Facility/Item: Sapaj Klean, Boynton Bch

RE: Response to Request for Additional Information Regarding Request for Modification of  
Hazardous Waste Operating Permit No. HO50-195905

RE: Request for modification of Hazardous Waste Operating Permit Ho 50-195905  
(Submitted on October 26, 1992).

Figure I.B.3-2  
Truck Traffic Patterns and Loading/  
Unloading Areas of Hazardous Waste  
Safety-Kleen Corp. Facility  
Boynton Beach, Florida

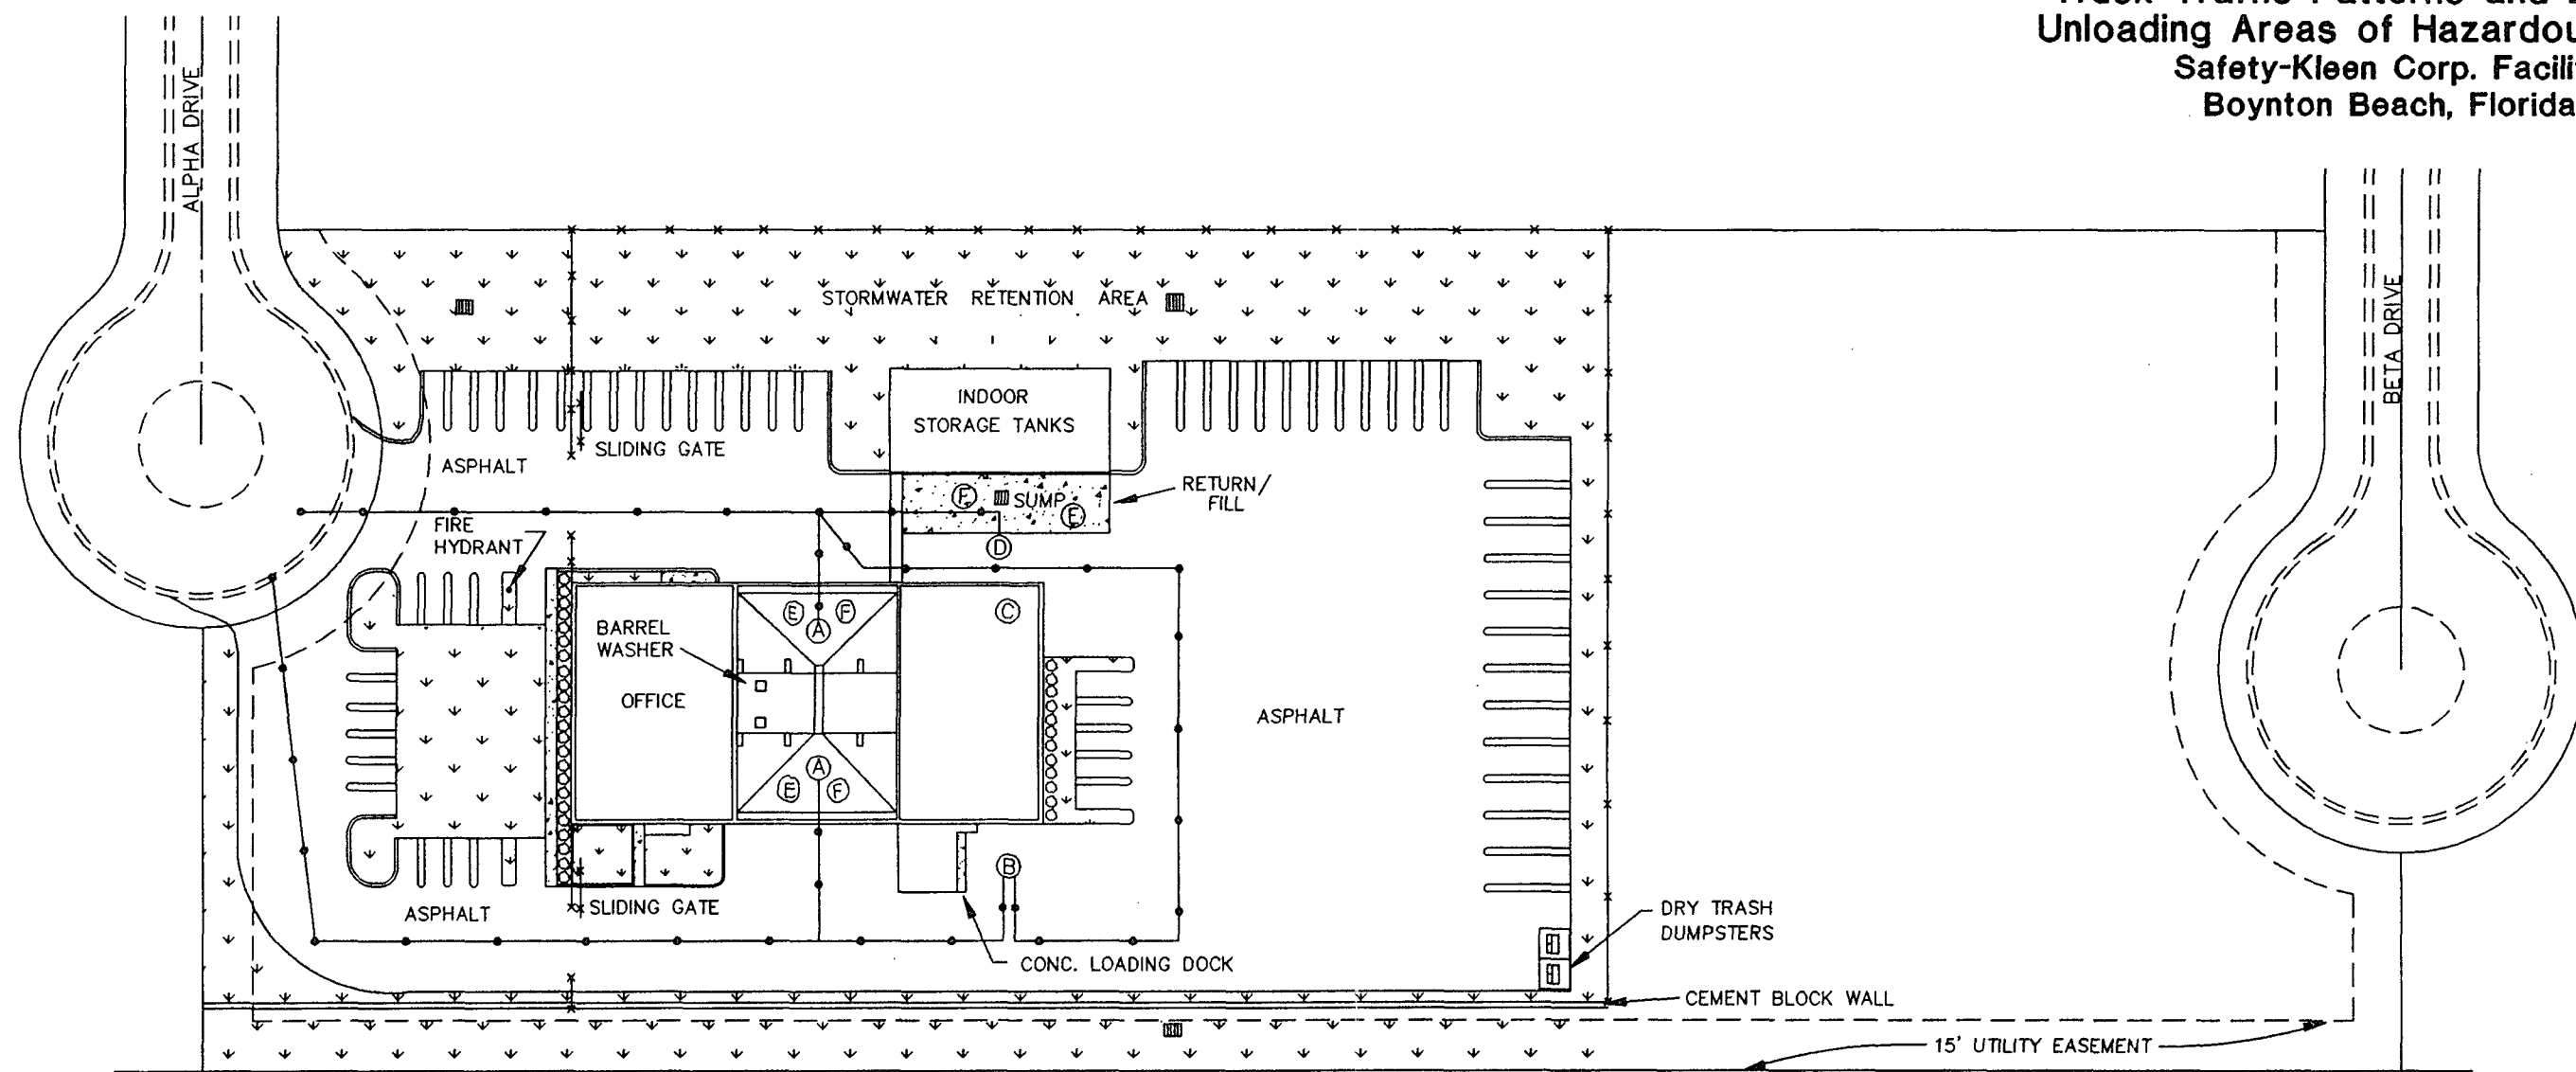
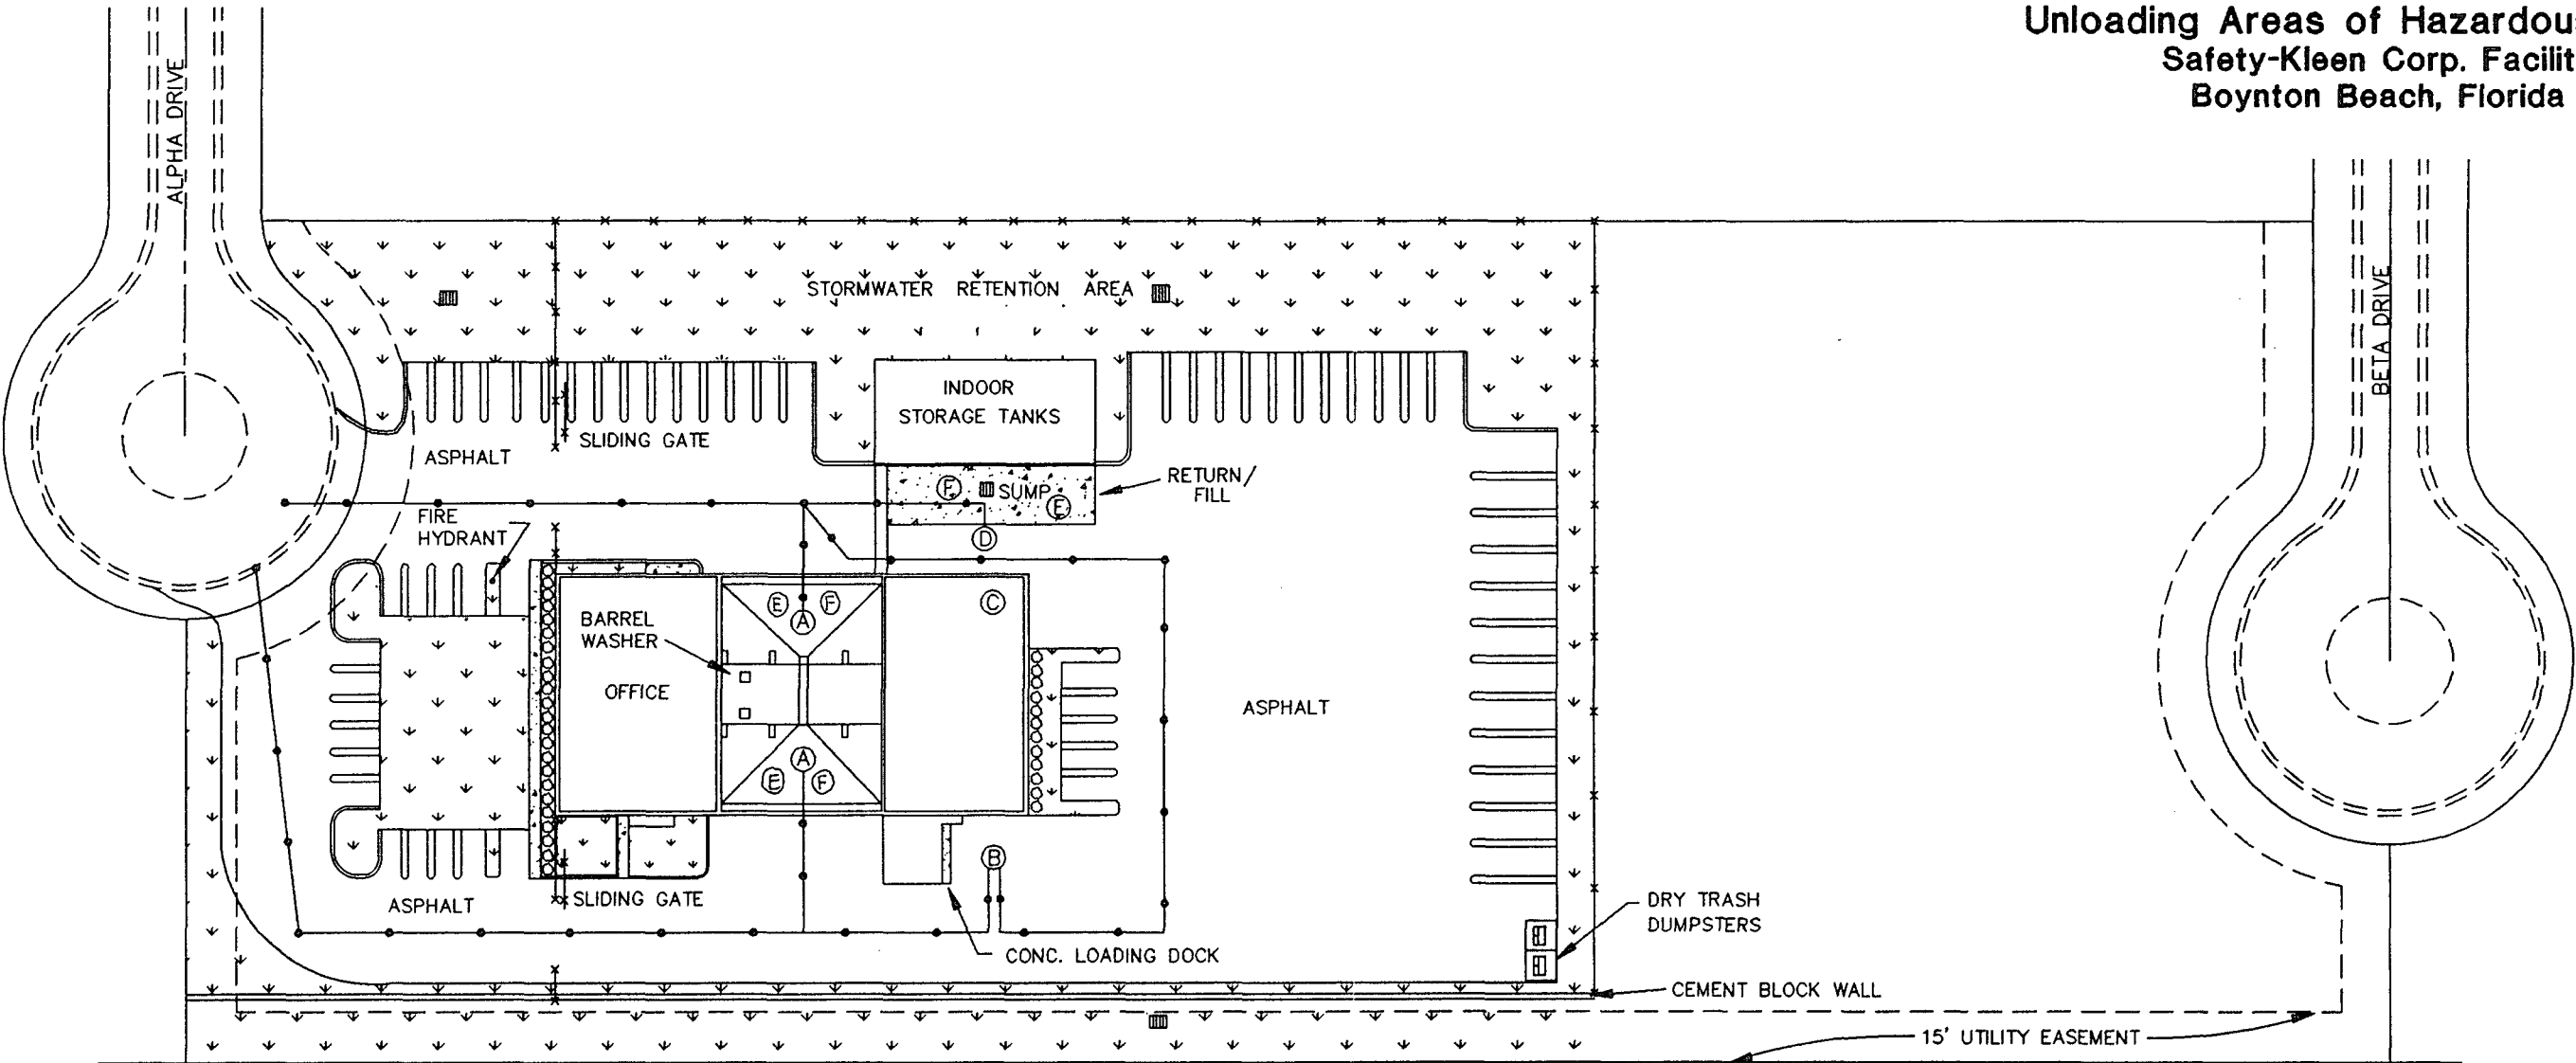
1. Safety-Kleen has requested that the permit include tanker truck to tanker truck transfer as an operating procedure. Safety-Kleen has provided a description and maps showing the location where the transfer may occur. The Department suggests that any truck to truck transfer of hazardous wastes should be conducted where secondary containment has been designed for such operations. The areas with appropriate secondary containment are shown in Figure II.A.1(c)-1. Either of the areas labeled "A" or that area labeled "D" would provide the containment necessary to prevent an accidental release from escaping to soils surrounding the facility. The transfer areas (Area E and Area F) proposed in Attachment I.B.3 do not take advantage of the safety features inherent to the facility's design. An accidental release could flow off of the asphalt and on to surrounding soils or flow down into the storm drain (not shown in Figure II.A.1(c)-1). Please submit a management procedure for truck to truck transfer which takes advantage of the containment systems designed and currently used at the facility for similar hazardous waste management activities.

The first item was with regard to the tanker-truck-to-tanker-truck transfer operations. SK has no objections to the agency's request to perform these functions within areas where secondary containment is available. The appropriate portions of the text and figures have been revised to indicate that tanker-truck-to-tanker-truck transfers will occur within the truck unloading area on the north side of the building. This area is sloped to a sump which provides secondary containment.

NOTE: E & F OCCURS ON THE TRUCK PAD  
NORTH OF THE WAREHOUSE
